PRODUCT/PROCESS CHANGE NOTICE (PCN)

PCN #: A1303-05	DATE: June 10, 2013	MEANS OF DISTINGUISHING CHANGED DEVICES:
Product Affected: 3.0mm x 3.0mm VFQFPN-20 4.0mm x 4.0mm VFQFPN-24 4.0mm x 4.0mm VFQFPN-28 (Refer to Attachment 2)		☐ Product Mark ☐ Back Mark ☐ Date Code ☒ Other Assembly lot marked on the device provides traceability to the material used
Date Effective: September 10, 2013

ATTACHMENT 1 - PCN # : A1303-05

PCN Type: Assembly Process and Material Change

Figure 1: Illustration of Interposer Inserted between top die and bottom die (Top View)

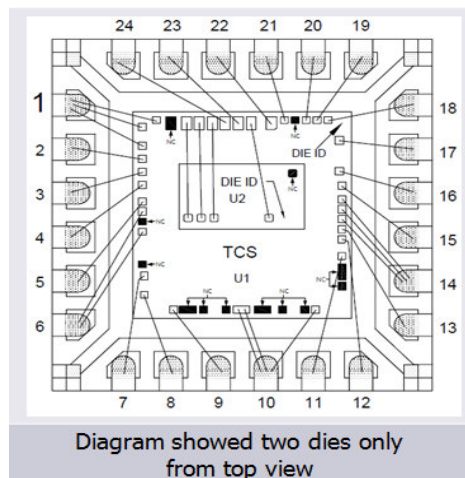
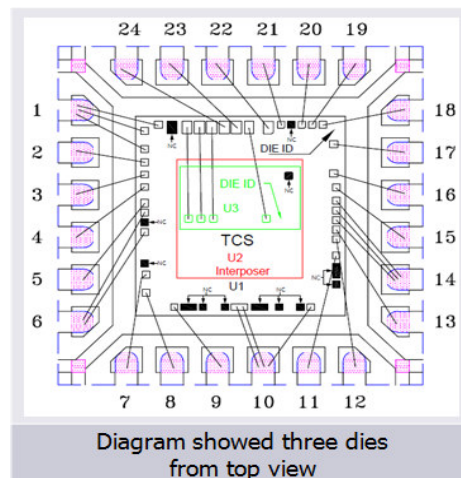
This notification is to advise our customers that IDT has successfully completed the qualification of stack die assembly with interposer. An interposer will be added in between the top die and the bottom die to improve assembly yield.

The die attach material for the top die will change to NEX-130SB-25 and for the bottom die to 8200T.

Old: Without Interposer

New: With Interposer

Figure 2: Illustration of Interposer Inserted between top die and bottom die (Side View)

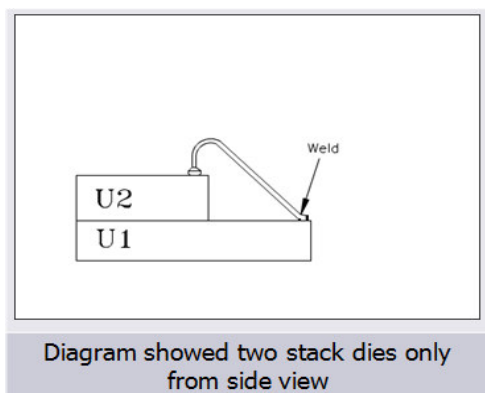
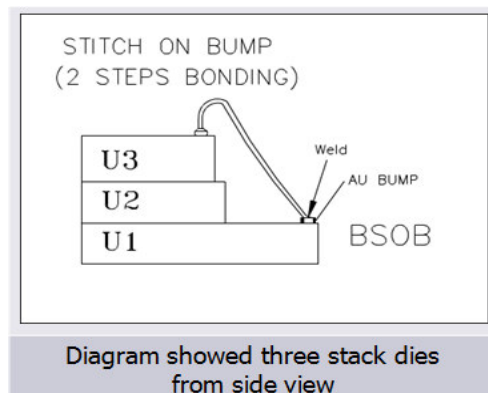
Old: Without Interposer

New: With Interposer
